JONES & BEACH ENGINEERS INC.

January 18, 2022

RE: Response Letter
19 Old Gonic Road, Rochester, NH
Tax Map 131, Lot 1
JBE Project No. 21090

DRAWING No.
OVRS
SHEET 8 OF 48
JBE PROJECT NO. 21090

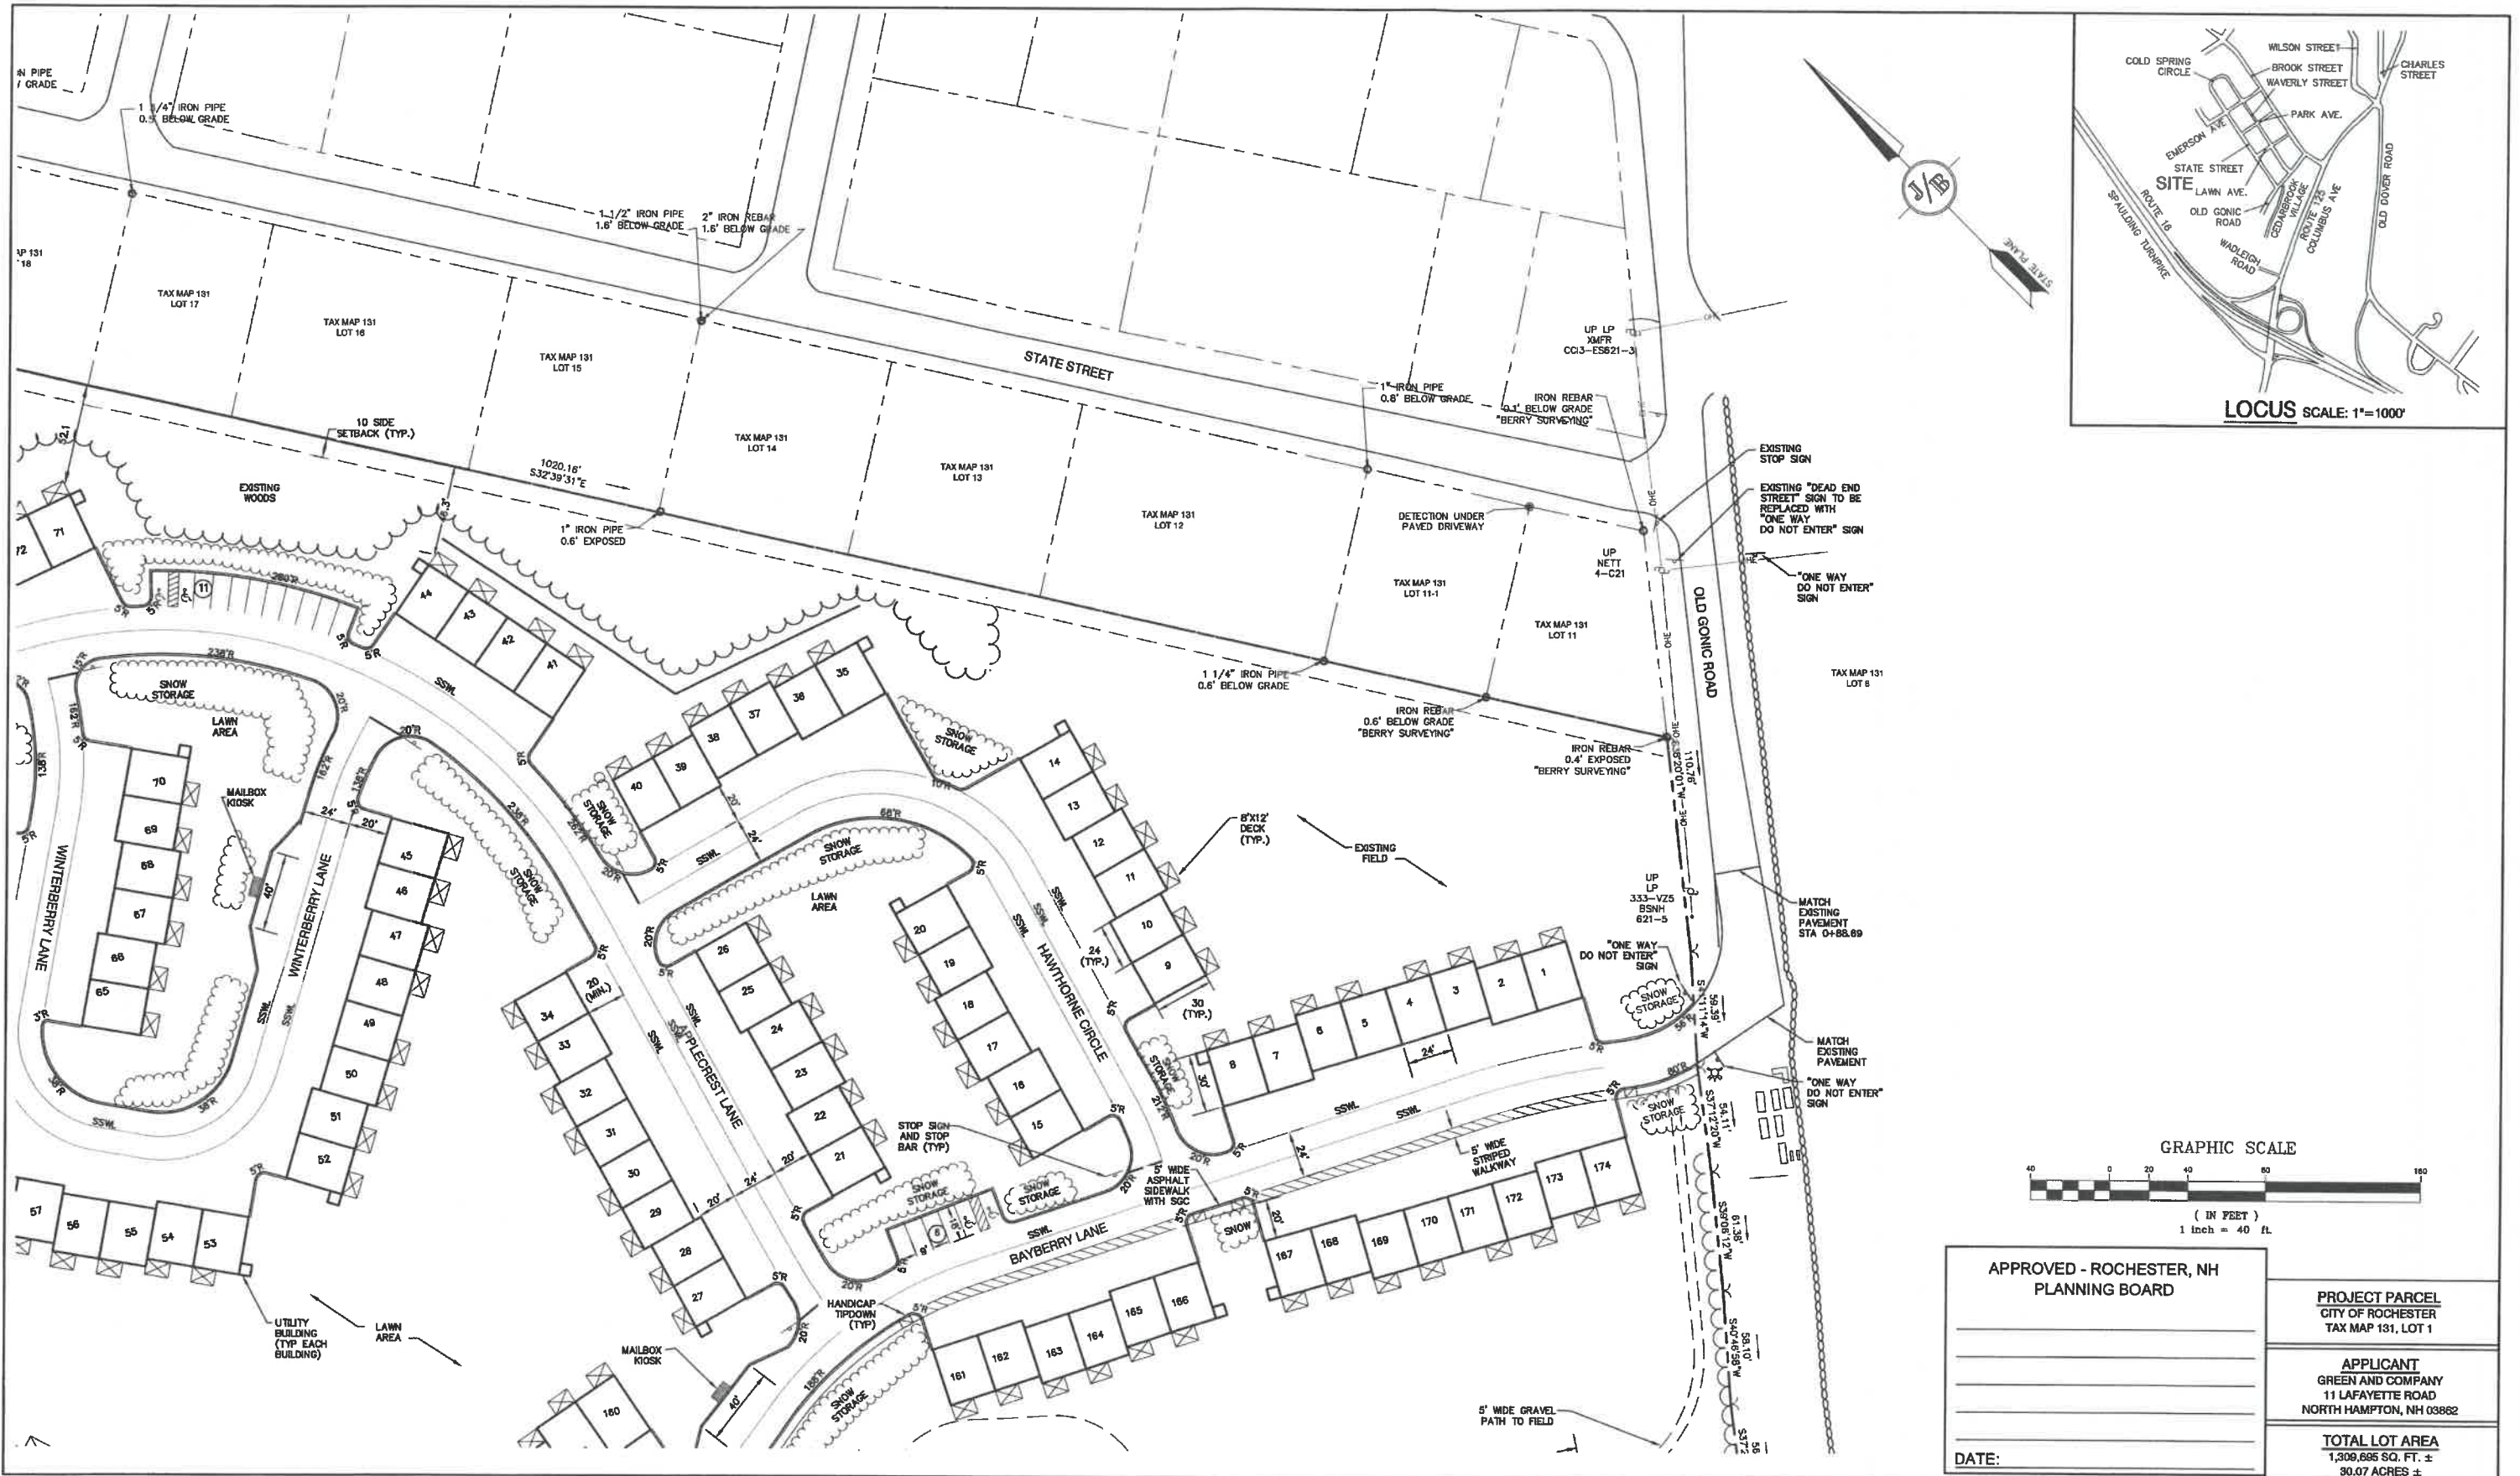
5. *Per Section 5.B.12 of the Site Plan Regs 25% of the entire lot must be unaltered or landscaped. Please make sure you meet this requirement.*

RESPONSE: The unaltered or landscaped area is labeled in Note #2 on Sheet OVRS.

DRAWING No.
L1
SHEET 20 OF 48
JBE PROJECT NO. 21090

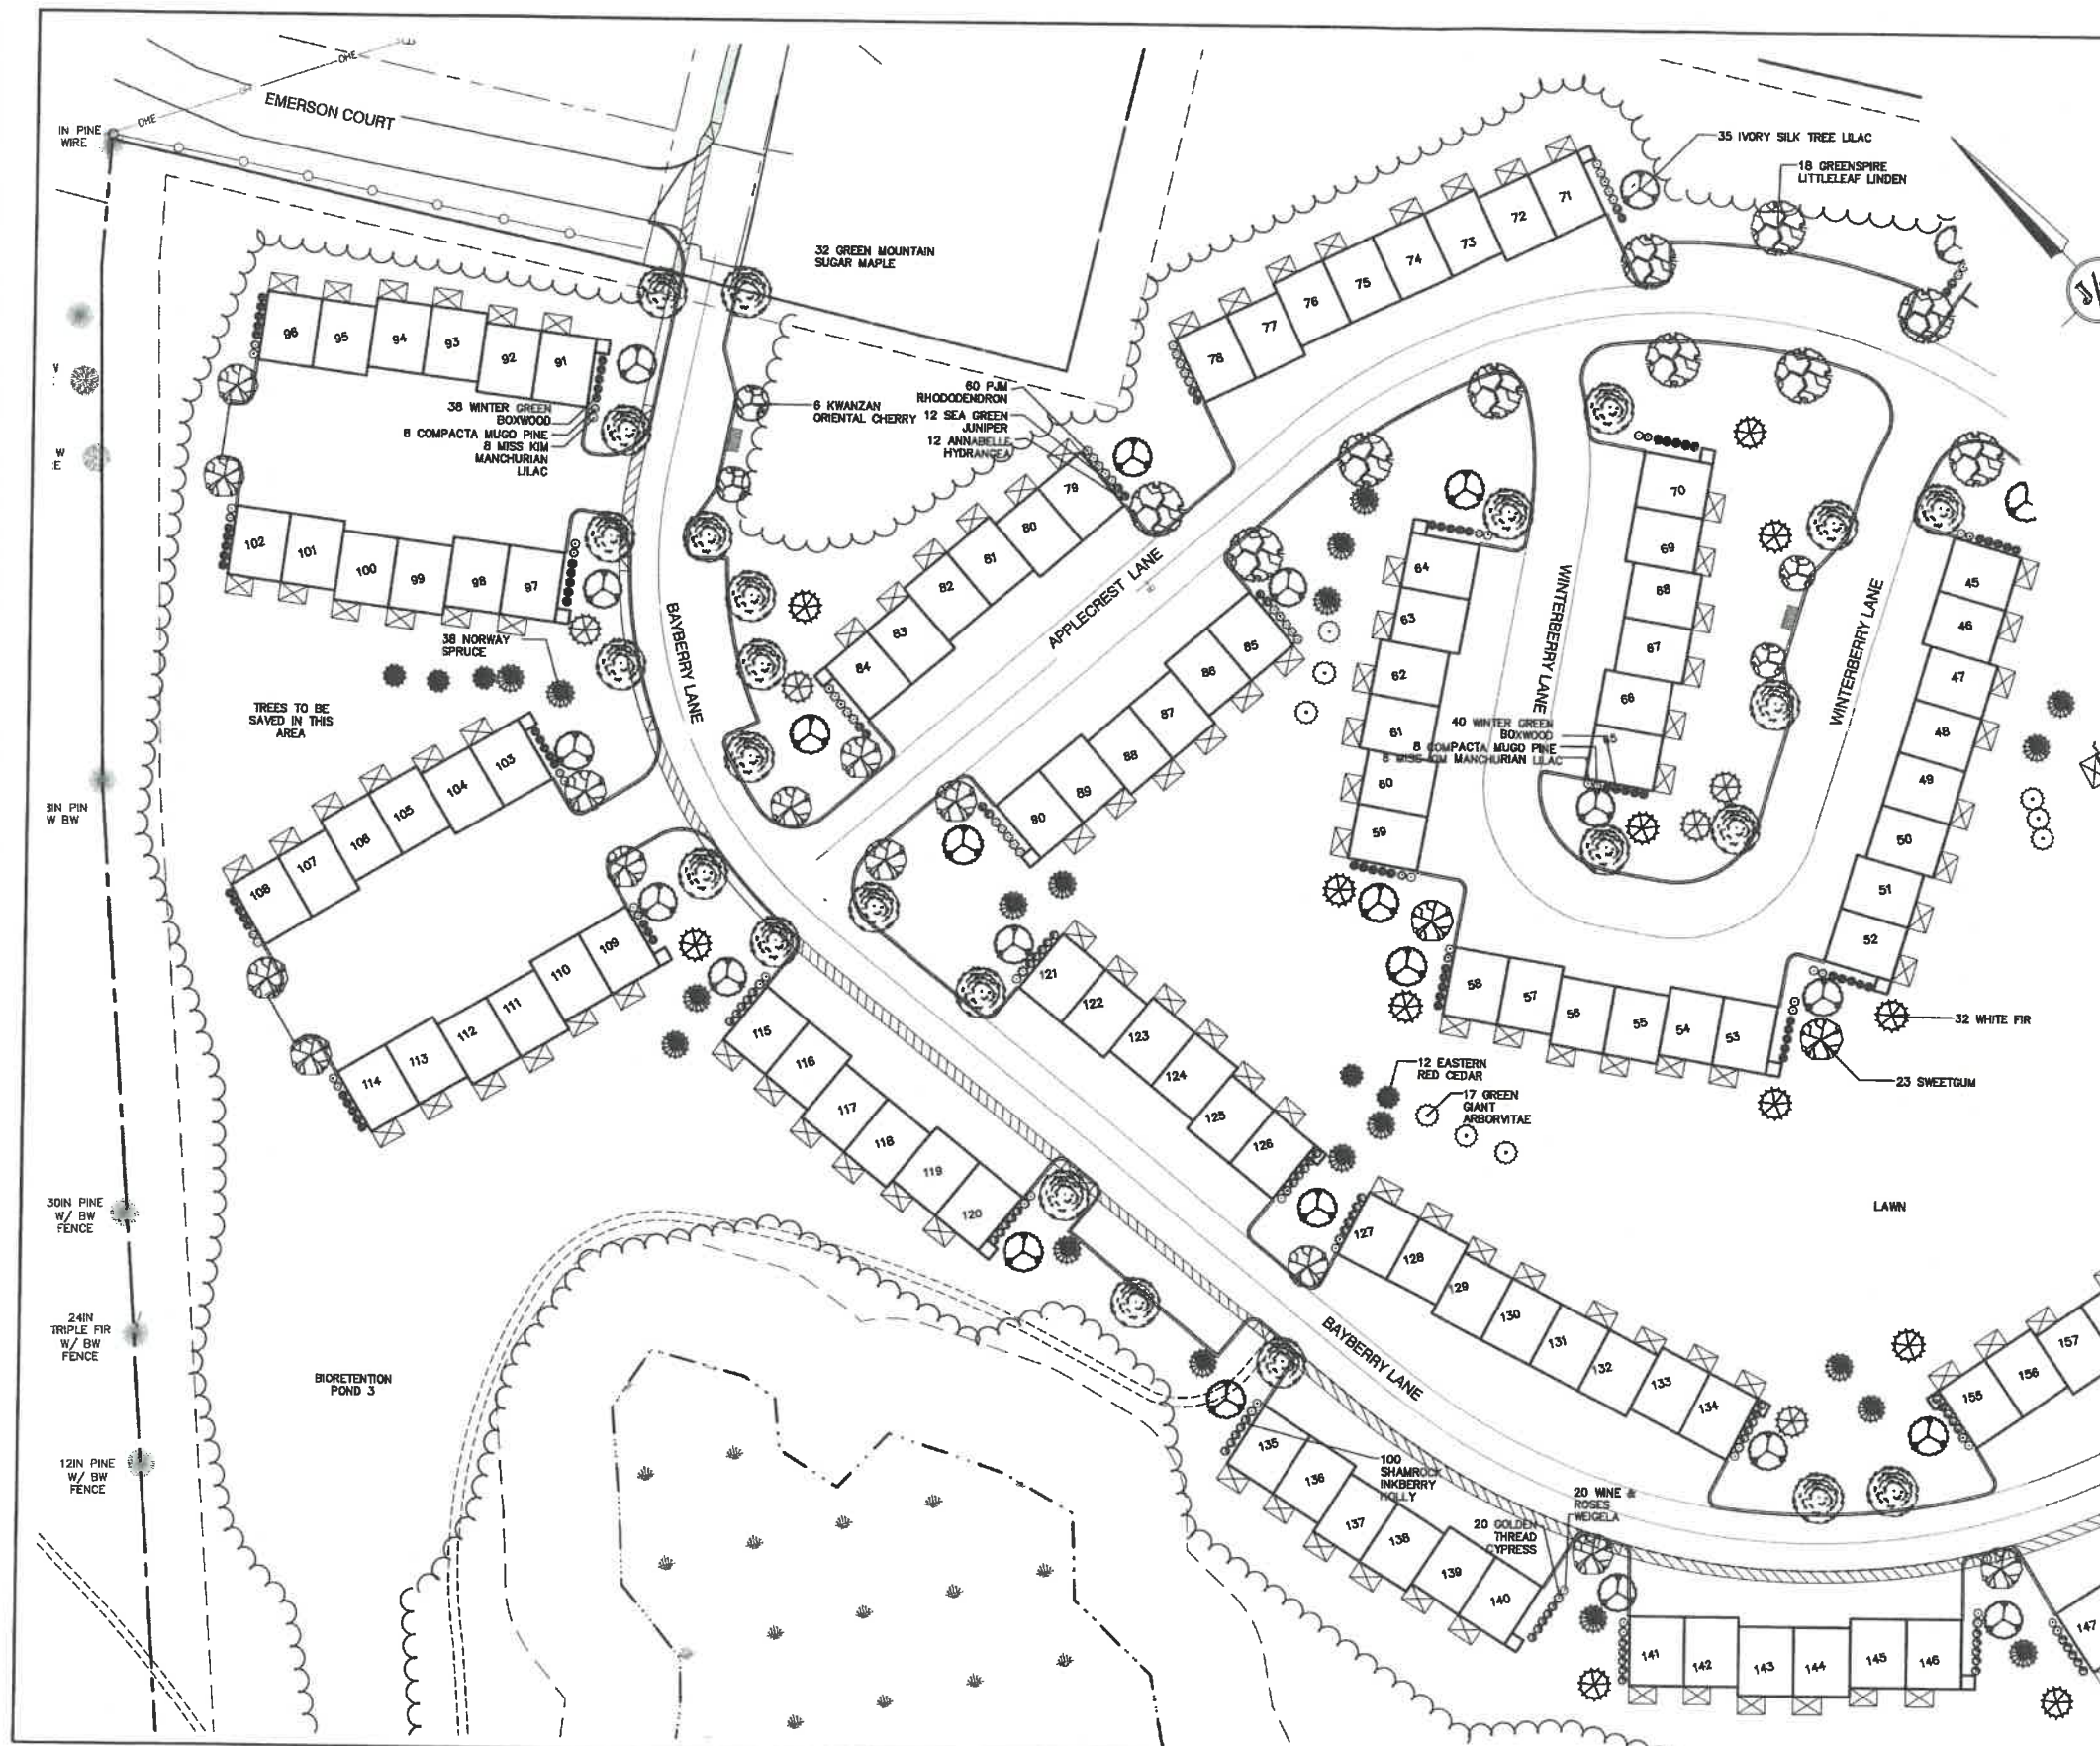
4. *Please add a key to the Landscaping Plan identifying which image is which kind of plant.*

RESPONSE: A key has been added to the Landscaping Plan identifying which image is which kind of plant.

DRAWING NO.
L4
SHEET 23 OF 46
JBE PROJECT NO. 21090

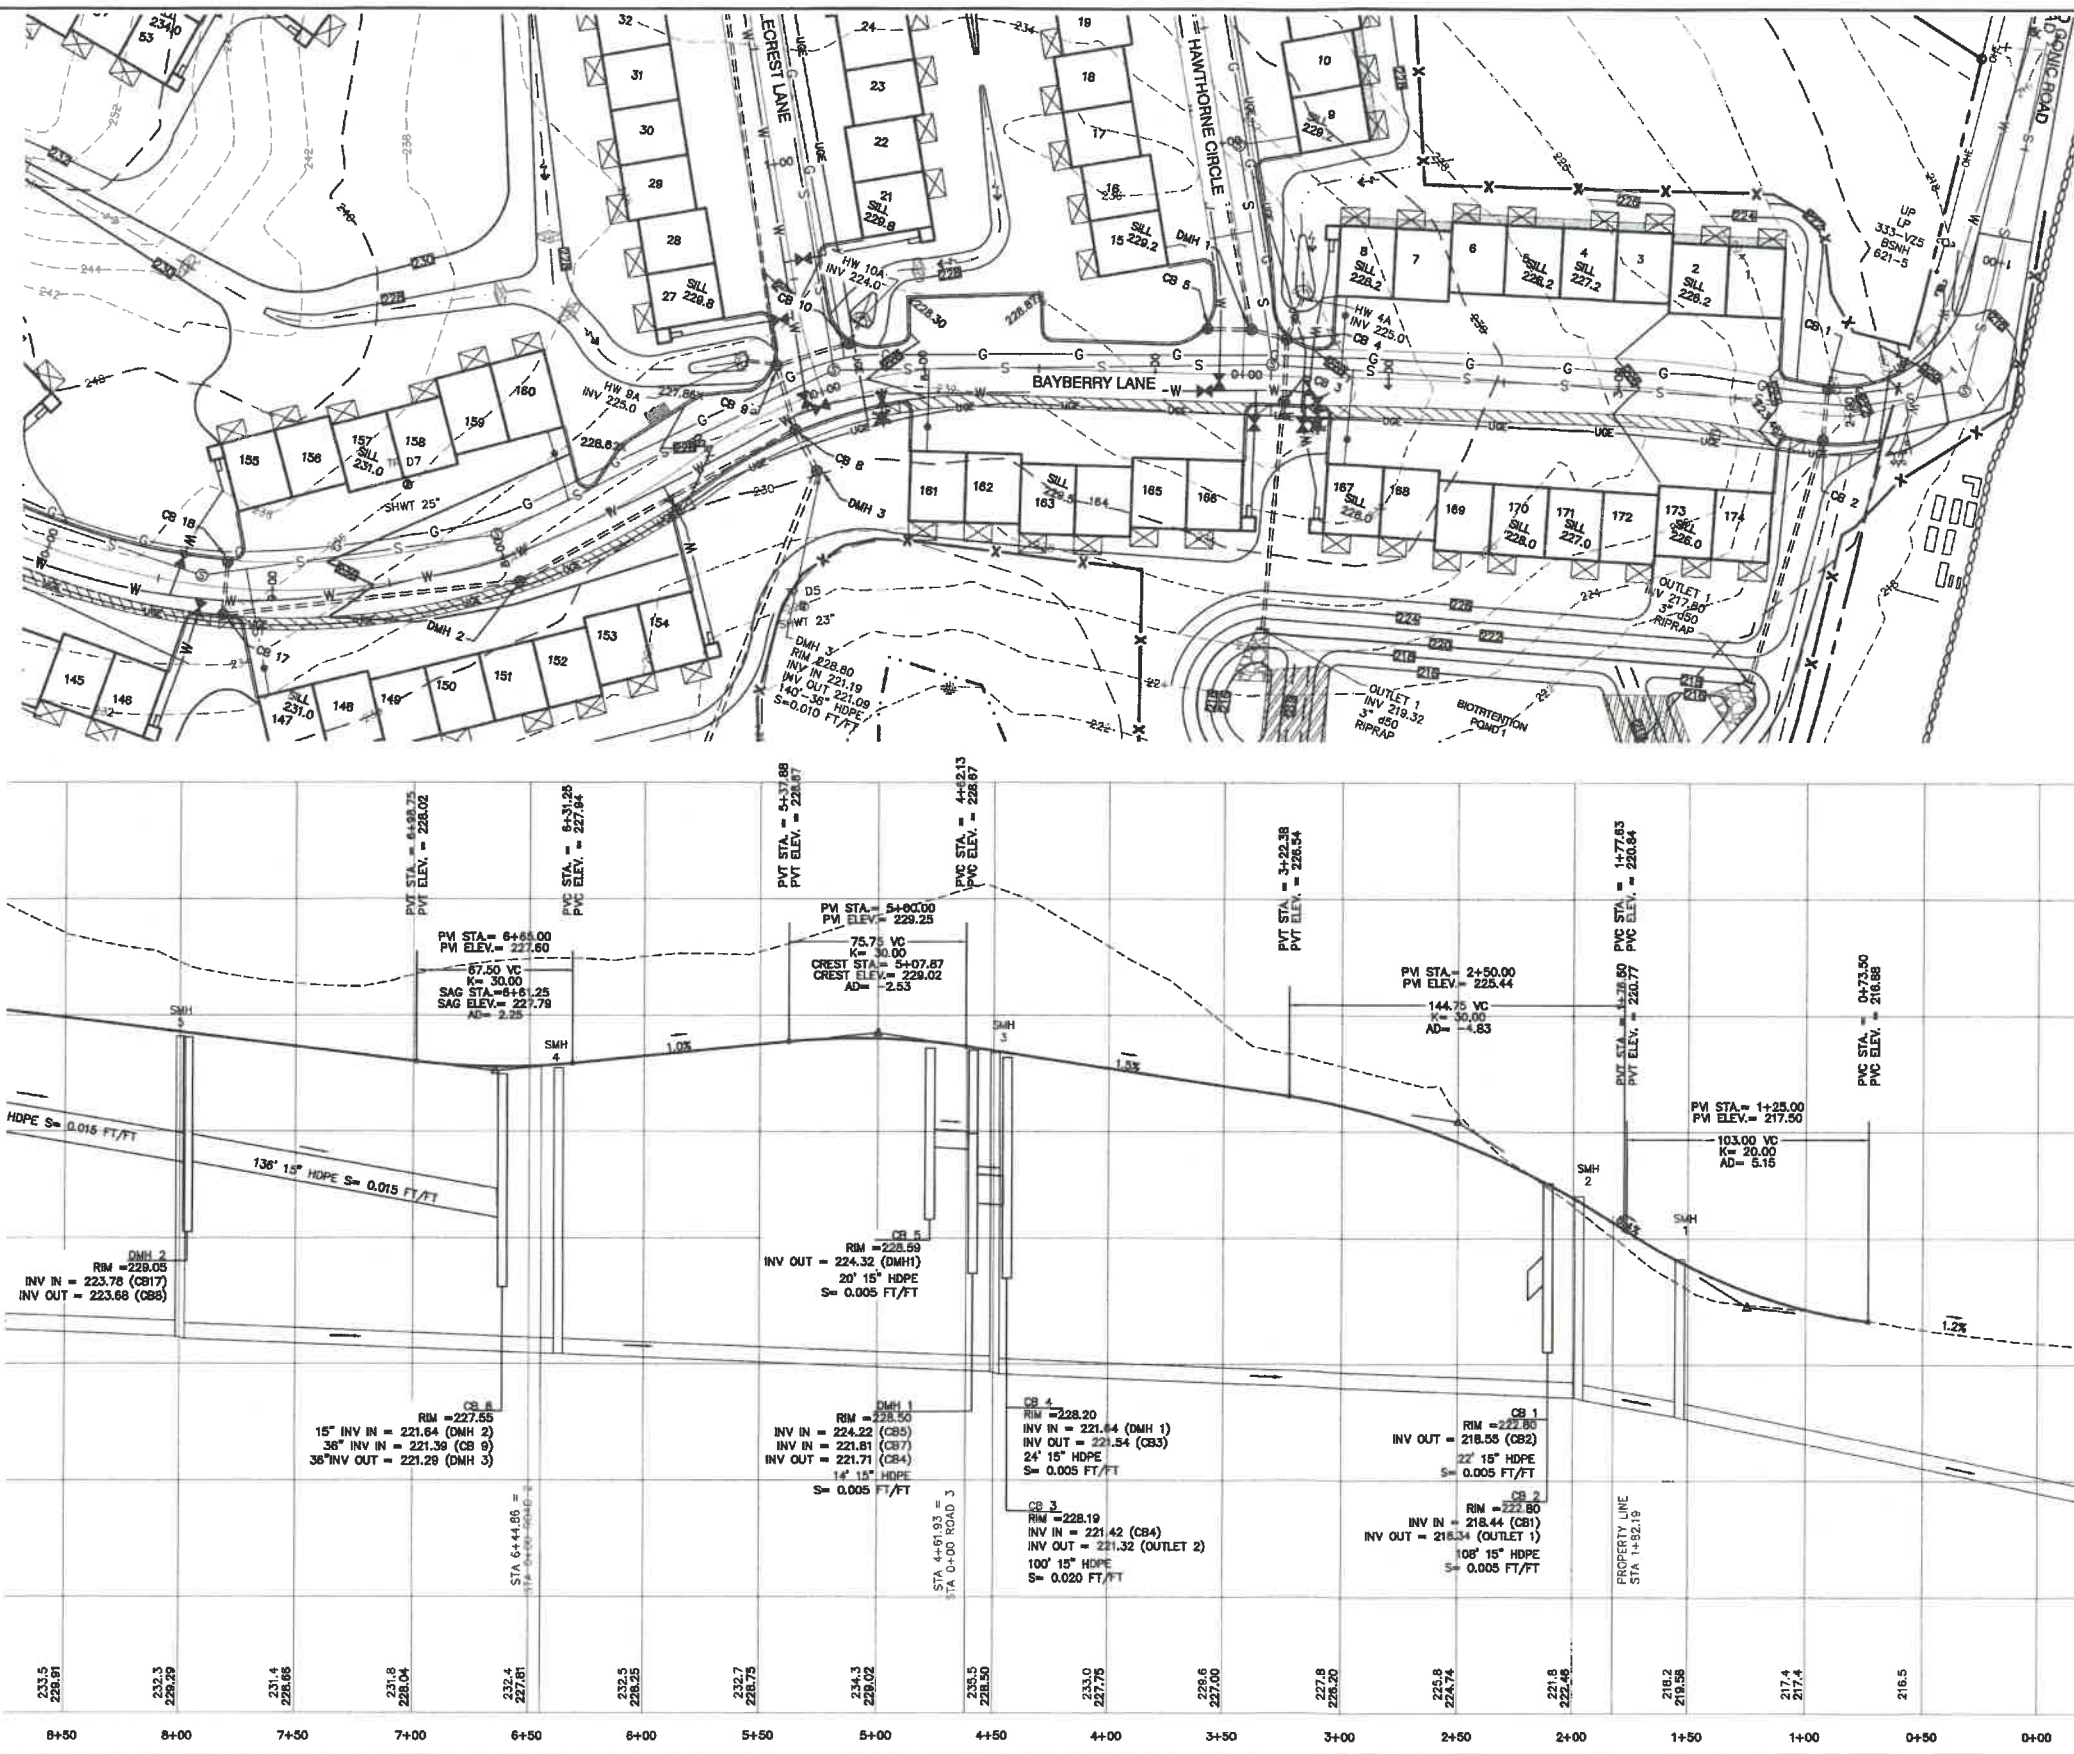
10. *All lighting, both parking lot and building must be downcast and fully shielded to prevent glare. Please add fixture type to plan.*

RESPONSE: A fixture type has been added to Sheet L4 for the poles and the wall packs on the building. All are dark sky compliant and are noted as such on the plan.
